SAS-2 S-Parameters of Cable Assemblies and Backplanes (08-187r0)

Barry Olawsky
Hewlett Packard
(5/6/2008)

Cable Assembly Data

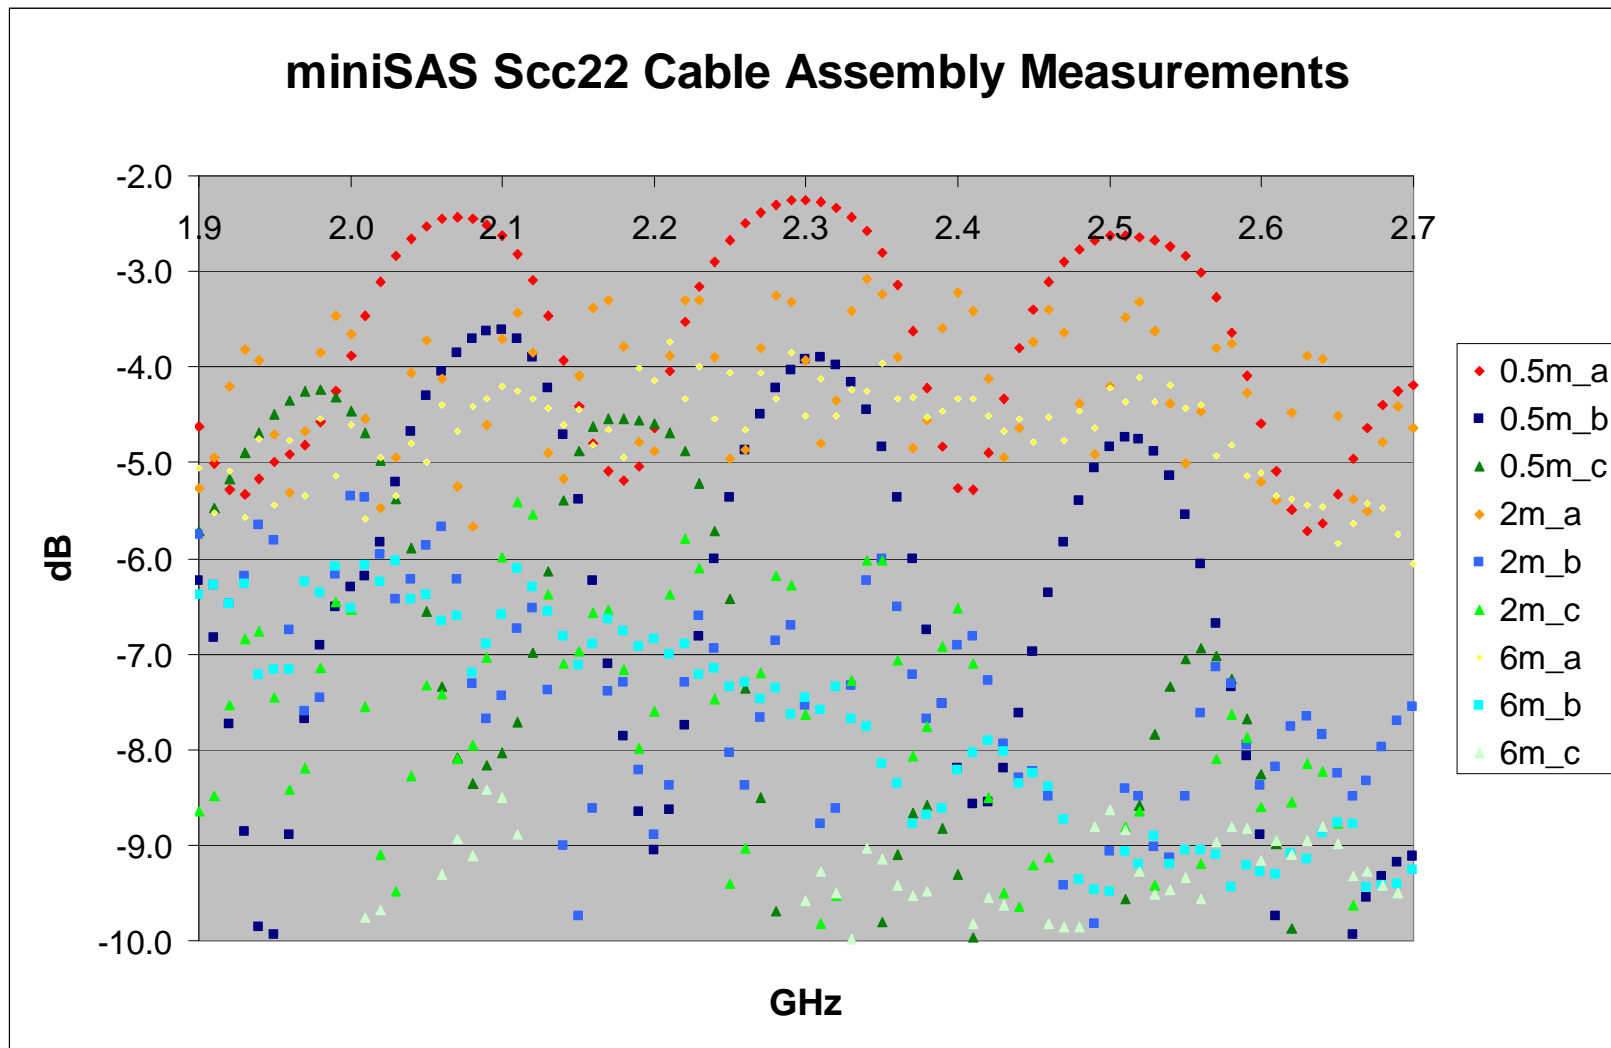
Cable Assembly Data Notes

- Samples consisting of three cable lengths from three different suppliers were measured
- Fixturing was not de-embedded but the test board traces maintained a well controlled 25-ohm common mode impedance up to the miniSAS connector footprint
- The miniSAS connector/cable interface has at least three unique coupled regions with each one yielding a unique common mode impedance ... PBC mounted connector, paddle card and bulk cable

Common Mode Impedance Variations in Board Design

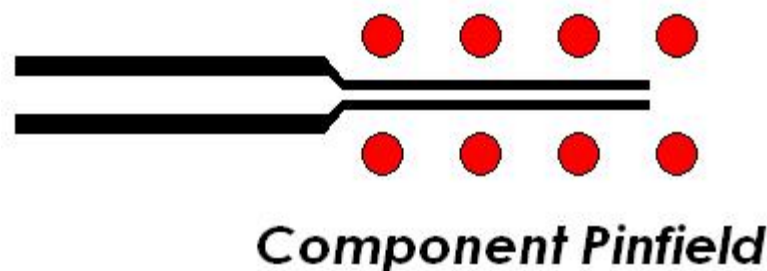
- Trace structure variation is a common layout practice
- Trace width and spacing are varied in order to access all points in connector and BGA pinfields
- Differential impedance is maintained while common mode impedance variations are tolerated

Trace Structure Simulations

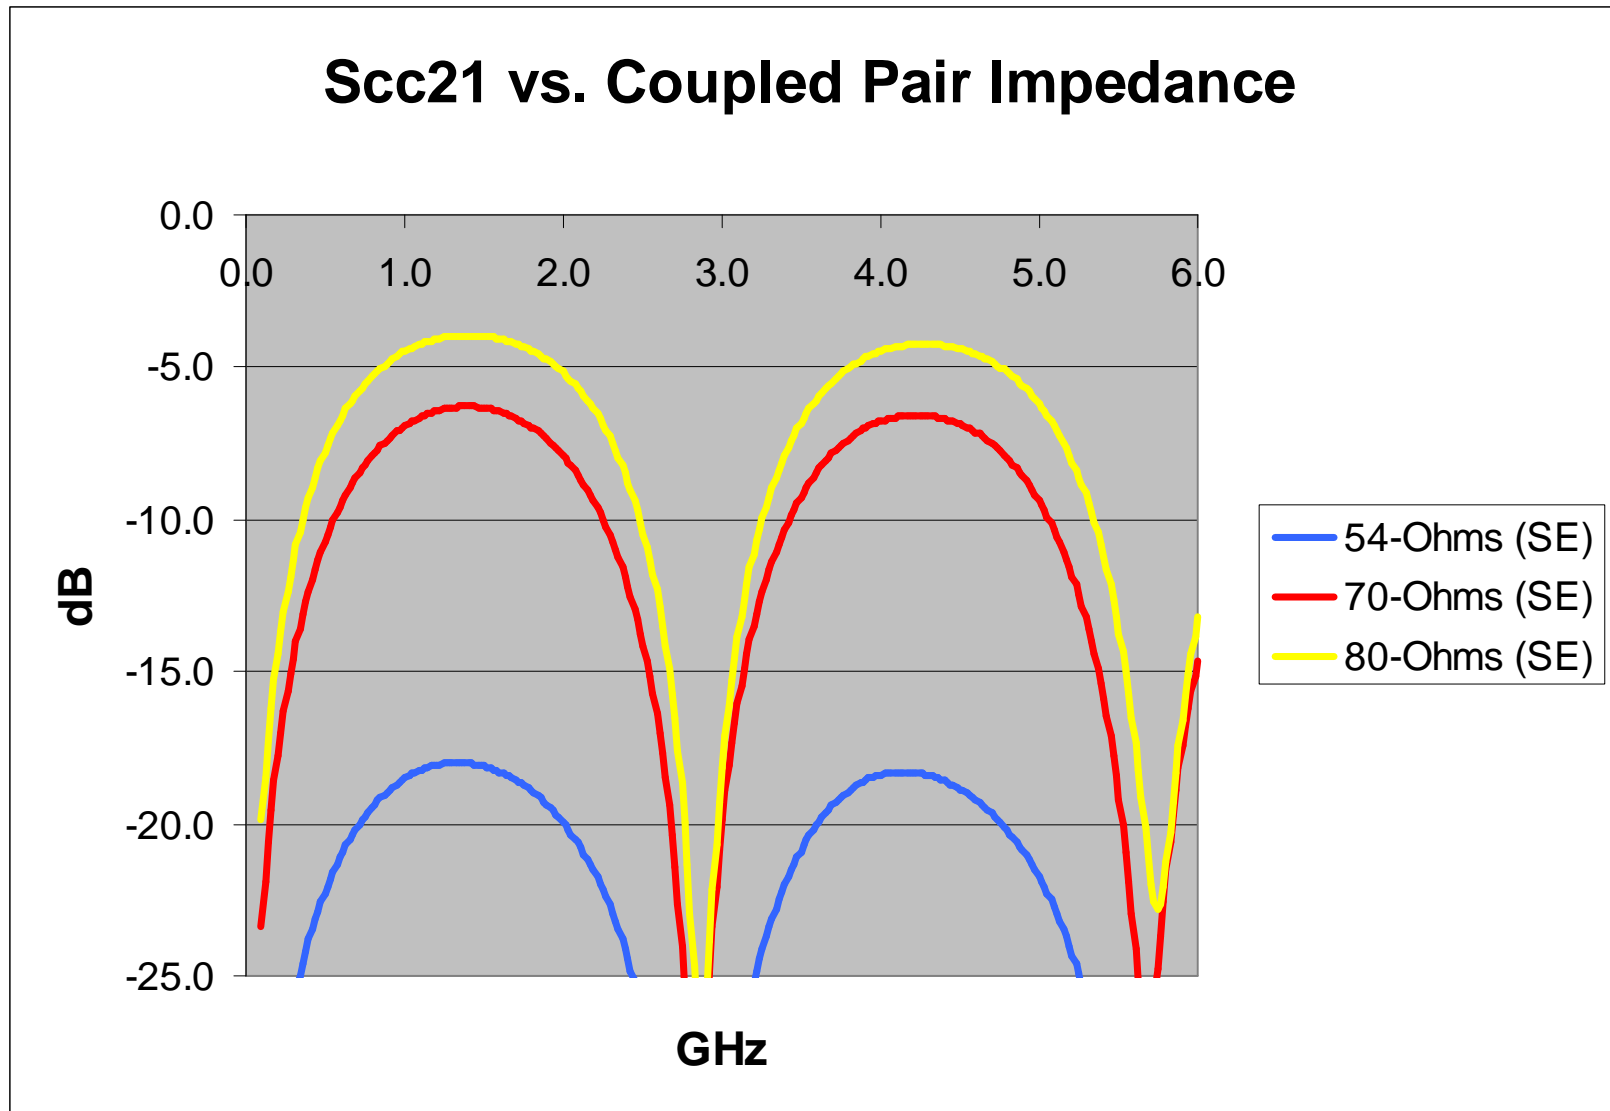
- To better characterize the effects of such layout practices, three separate designs are simulated.
 - One inch uncoupled microstrip + one inch 100-ohm differential coupled microstrip with a single ended impedance of 54-ohms + 50-ohm termination for each leg
 - One inch uncoupled microstrip + one inch 100-ohm differential coupled microstrip with a single ended impedance of 70-ohms + 50-ohm termination for each leg
 - One inch uncoupled microstrip + one inch 100-ohm differential coupled microstrip with a single ended impedance of 80-ohms + 50-ohm termination for each leg
- The model is driven by a common mode source and then converted to S_{CC22} format.

Multiple Impedance Discontinuities

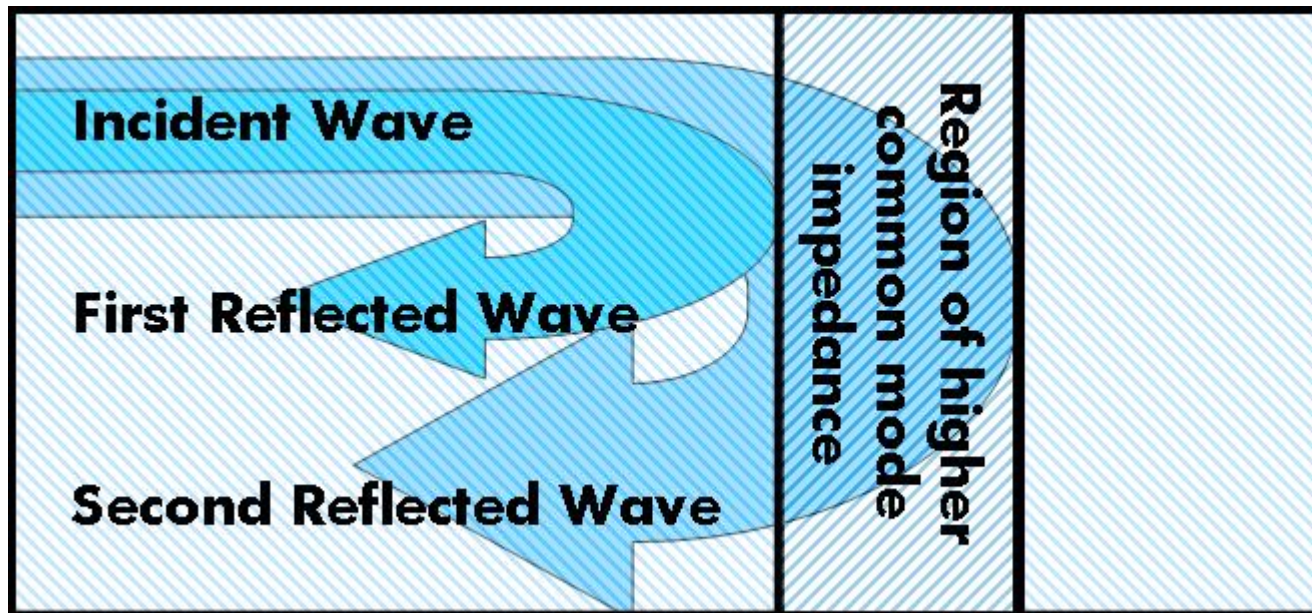
- Each change in common mode impedance will introduce a wave back to the compliance point. Multiple changes between 25 and 40 ohms will result in a return loss greater than -12.7dB at specific frequency points

Potential Scd22 Issues

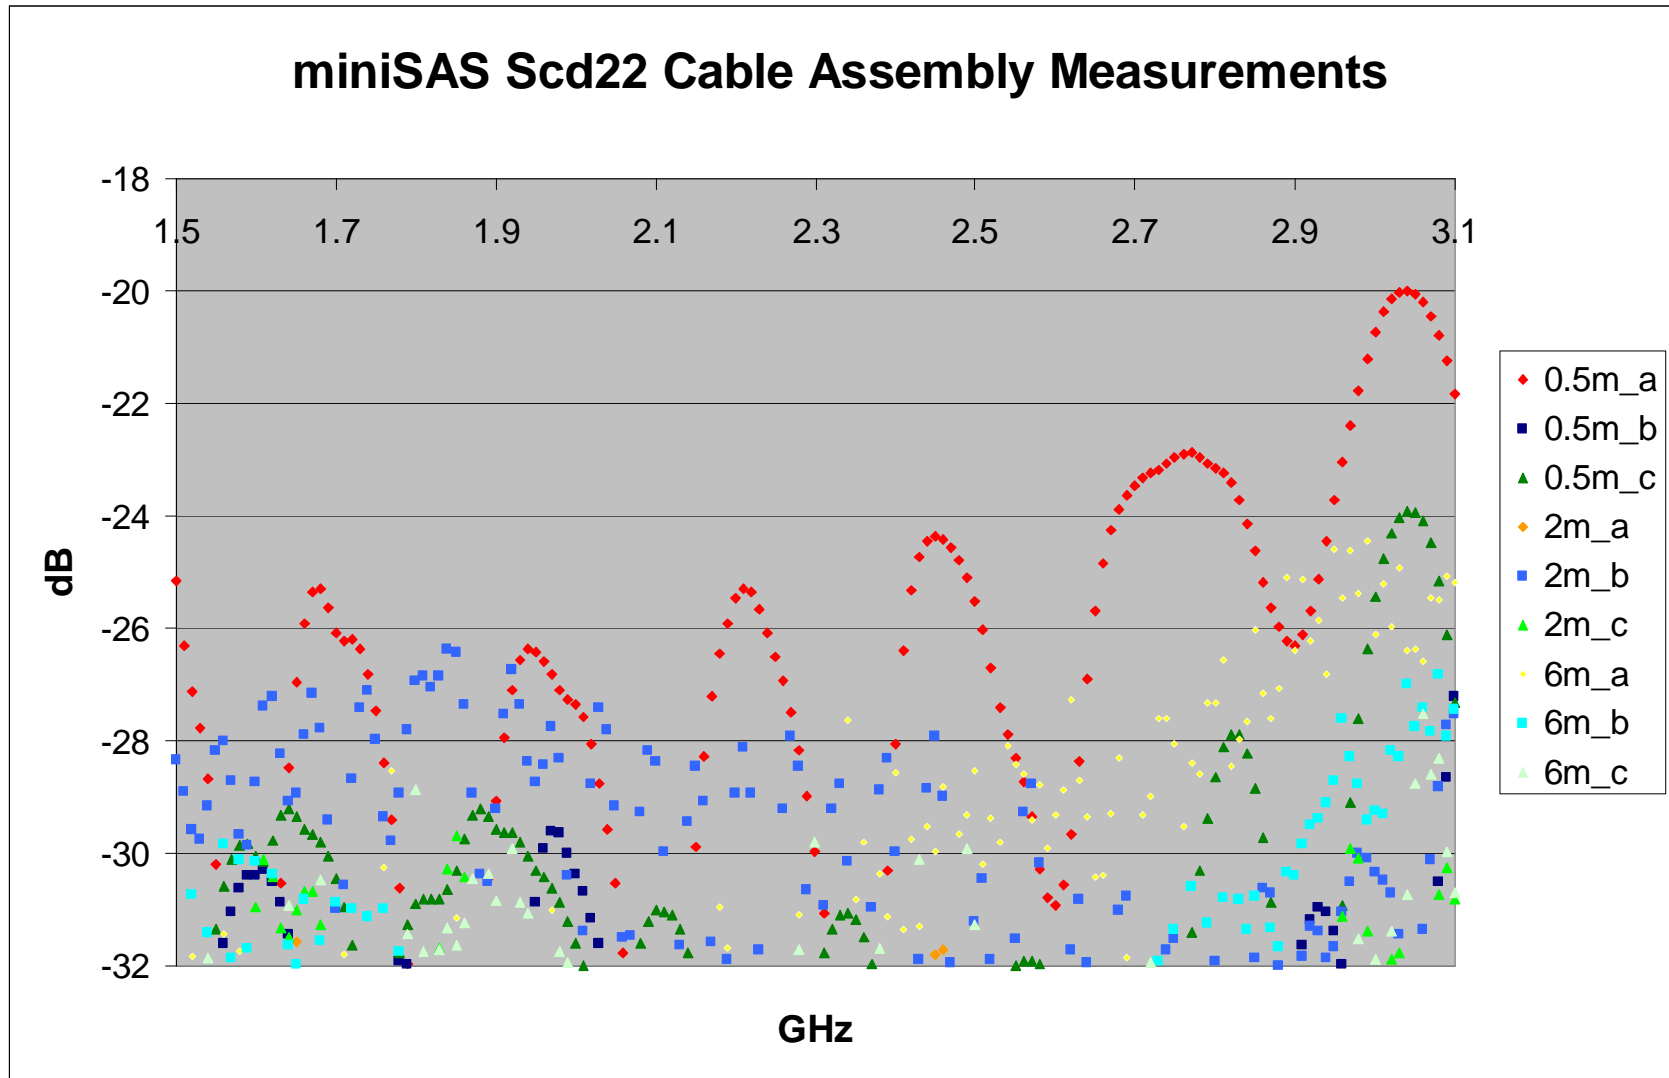
- Imperfect twin-axial cable termination is very common. Any imbalance introduced during the assembly process can result in non-ideal mode conversion parameters (all S_{CD} and S_{DC} terms).
